COMPLIANCE CONDITIONS 2 & 31

for PROPOSED RESIDENTIAL DEVELOPMENT
CLONBURRIS STRATEGIC DEVELOPMENT ZONE
PHASE T3

November 2023

IMAGE 3 – REVISED NORTHERN CORE - GROUND FLOOR PLAN PROPOSAL

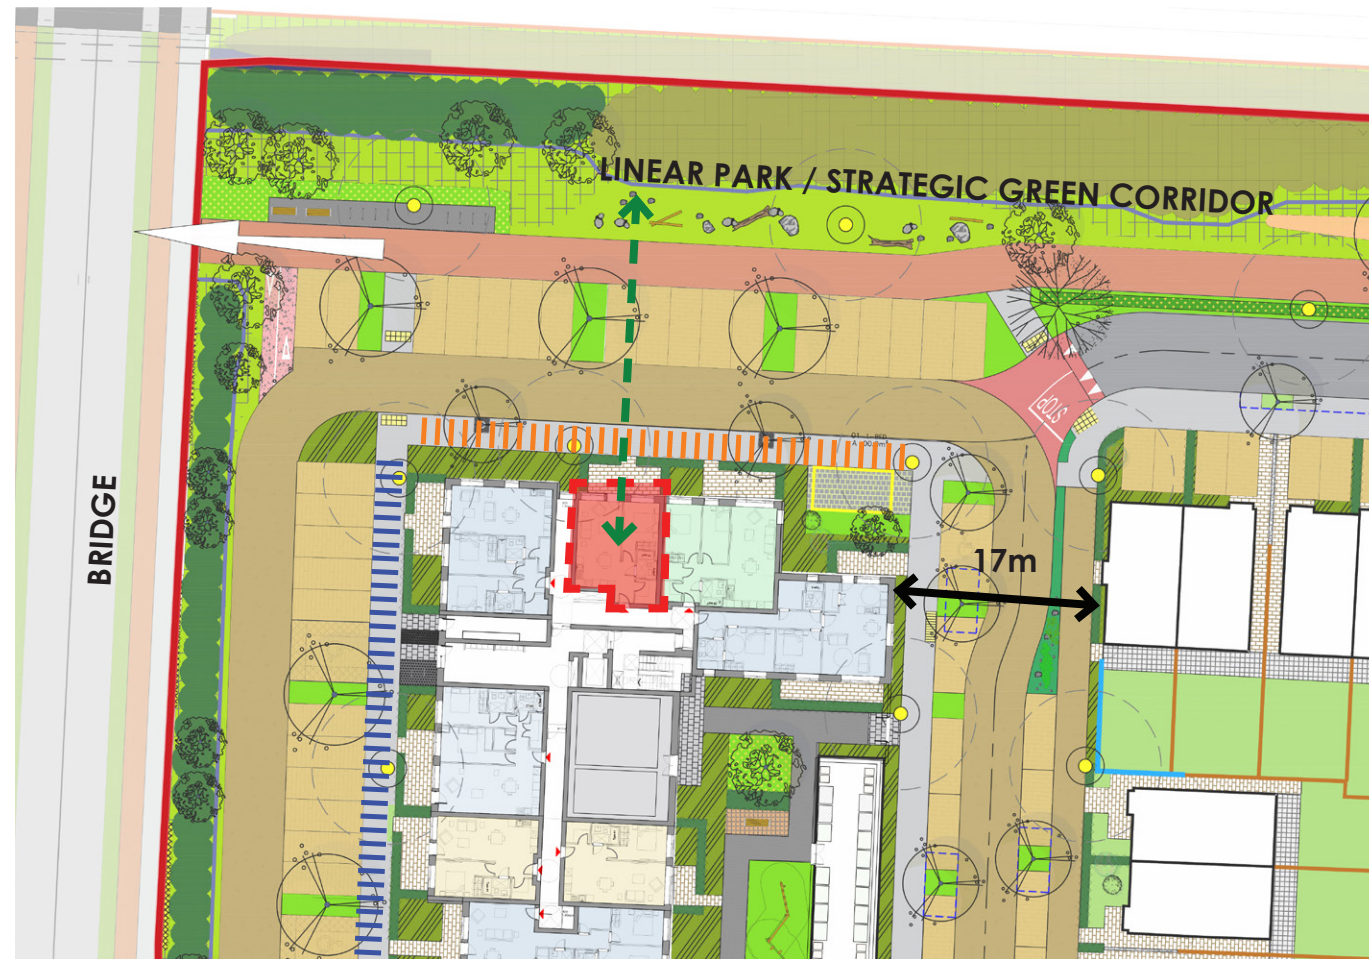
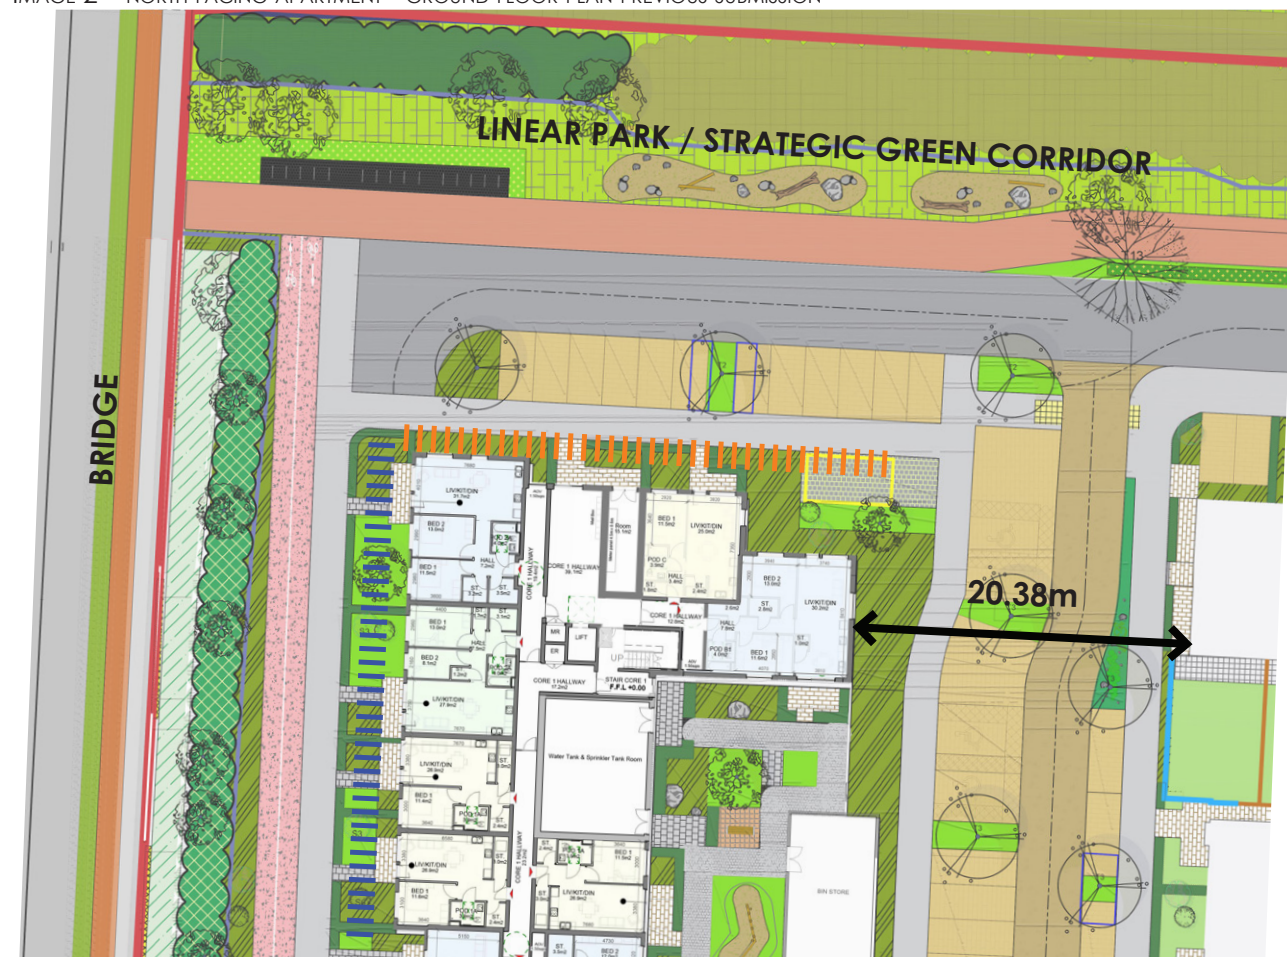
Unless otherwise agreed revised plans that incorporate all of the following amendments-
 (a) The ground floor single aspect north facing apartment shall be amalgamated with the adjacent apartment. All upper floor north facing single aspect apartments shall be redesigned to provide additional private amenity space. An updated Schedule of Accommodation, HQA and Schedule of Areas shall be provided.

In response to this item, and in tandem with condition 31 which requests the removal of the parking spaces on the western side of the apartment block, we propose an alternative arrangement to that proposed in condition 2. Our proposal amalgamates the 1 bed unit at ground floor with the neighbouring 2 bed unit as requested but also relocates the core entrance to the northern facade of the building, effectively swapping its location with the 1 bed unit on the western edge. This proposal retains the 76 units previously proposed. Furthermore, the removal of the parking spaces along the western side of the building as requested in condition 31 means that the revised entrance location is now more conveniently located in relation to the amended parking layout and the retained apartment avails of a more favourable aspect/interface to the west.

On the northern facade, from the 1st to the 3rd floors, we are proposing to provide larger balconies for the 1-bedroom units to provide additional private amenity space. For a more detailed breakdown of these modifications, please refer to the itemized HQA, which is included with the compliance documents.

A reduction in size of the ground floor apt. no. 120 is required to comply with statutory requirements, however it is proposed to allocate apt. no. 82 as a universal design unit in lieu of apt. no. 120

IMAGE 4 – SITE PLAN - BRIDGE EMBANKMENT FEASIBILITY

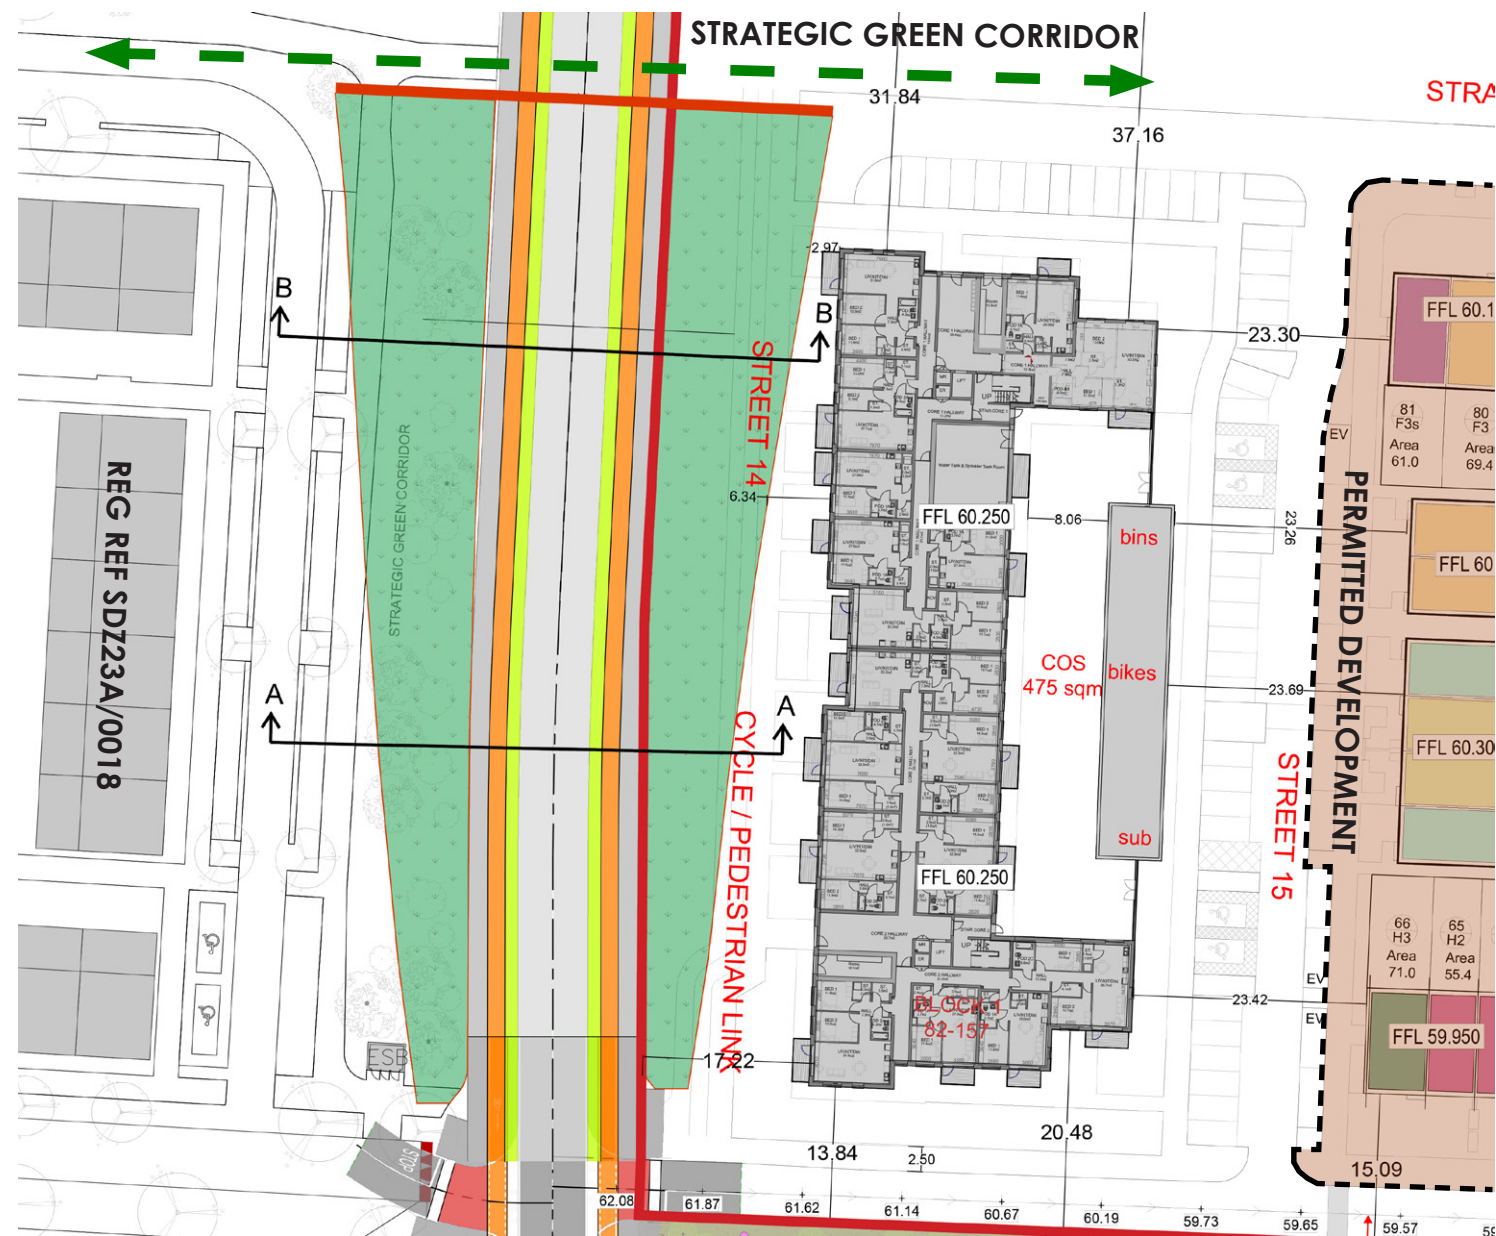
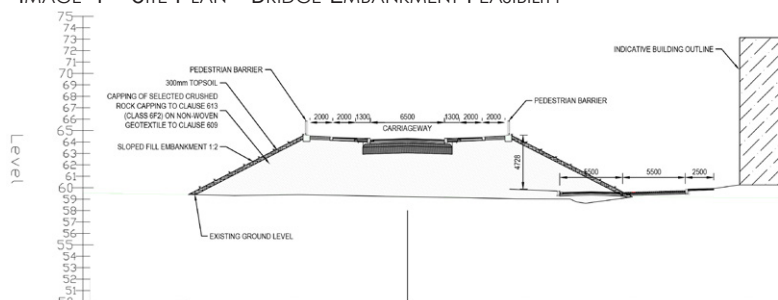
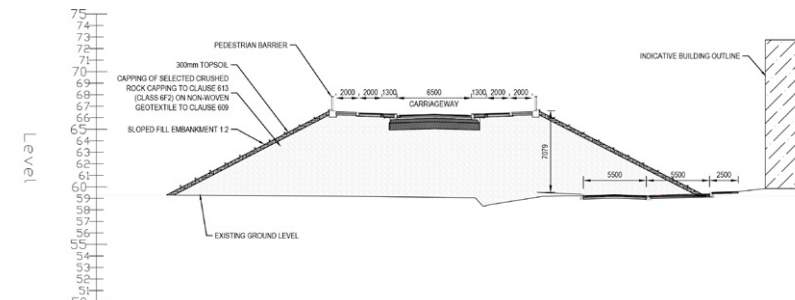
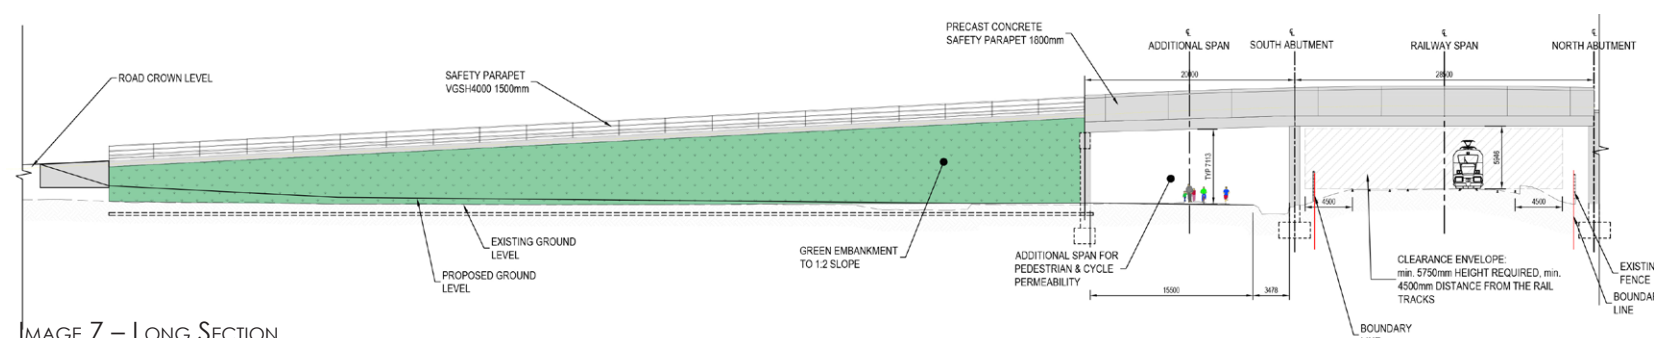
i. The feasibility of the bridge and the requirement for and extent of an associated embankment;

The team has undertaken a feasibility study of an embankment scenario for the vehicular bridge to assess its potential impact on the site plan and apartment design, as well as a cost analysis. As part of this exercise, 3 scenarios for the bridge were explored.

As well as being the most expensive alternative, we respectfully submit that the embankment scenario appears at odds with the objectives set out in the planning scheme. Most notably, the linear park located parallel to the rail line which is to run uninterrupted from east to west, connecting the Clonburris and Kishogue Urban centres. This vital site connection will necessitate a pedestrian and cycle route which passes underneath the bridge. With the embankment scenario, the area under the bridge measures 50 metres in length. By comparison, in the landscaped retaining wall scenario (refer to page 8), as submitted at planning and further information stages, the span under the bridge is 17m. Given its length the 50m span has potential to facilitate anti-social behaviour as well as introducing a general less inviting environment for the proposed east-west link.

The height and land take for the embankment will result in a greater negative impact on the quality of the amenity space for the adjacent residential blocks. In order to mitigate this impact the developable land available for the apartment block would be reduced. This could, in turn, impact the target dwelling numbers required for compliance with planning scheme objectives. It should also be noted that the quantum of developable land in this location has already been eroded by the 20m gas wayleave which runs along the R113 to the east of the subject site.

IMAGE 8 – PROPOSED PLAN

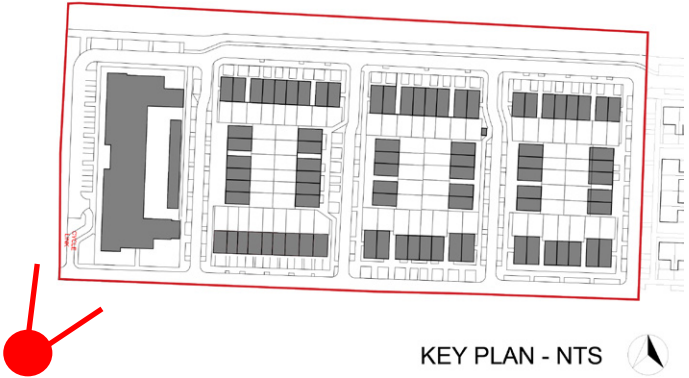
iii. Removal/ Relocation of the car parking within the area to the west of the apartment block, ensuring a parking ratio of approx. 0.4 is maintained for the apartments and the overall on / off curtilage parking requirement is in accordance with the scheme. Revised layout / landscaping plans should be provided if necessary;

The site layout has been revised, as requested by this condition, to remove parking spaces on the western side of the apartment block (as illustrated on image 8 to the left). The removal of all spaces on the western side of the building presents an opportunity to create a landscaped link, dedicated to pedestrian and cyclist movement between the strategic local corridor and the local park to the south of Block 1.

This condition means that the street formally street 14 is no longer required as a local street. A local street allows for a 23m width and parking on both sides of the street. We feel that it is appropriate to suggest a similar redesignation of Street 15 as a 'local Street' rather than a homezone, in order to relocate some of the parking lost as a result of the condition which removes spaces on street 14. This still represents an overall reduction in the quantum of parking dedicated to the apartments from a ratio of 0.67 to 0.51. Parking is still in compliance with the overall on / off curtilage parking requirements in accordance with the planning scheme.

Further to the above A reduction in the apartment block footprint will allow us to maximize the distance between the bridge and the residential units, safeguarding their amenity, as well as preserving adequate daylight and sunlight levels. These refinements have resulted in small reductions to overall dimensions as well as minor revisions to the units within the apartment block. Compliance with space standards for all residential units is maintained. We also have removed the step in the building between the northern and southern cores. We respectfully submit that the combination of these proposals will address the requirements of this condition.
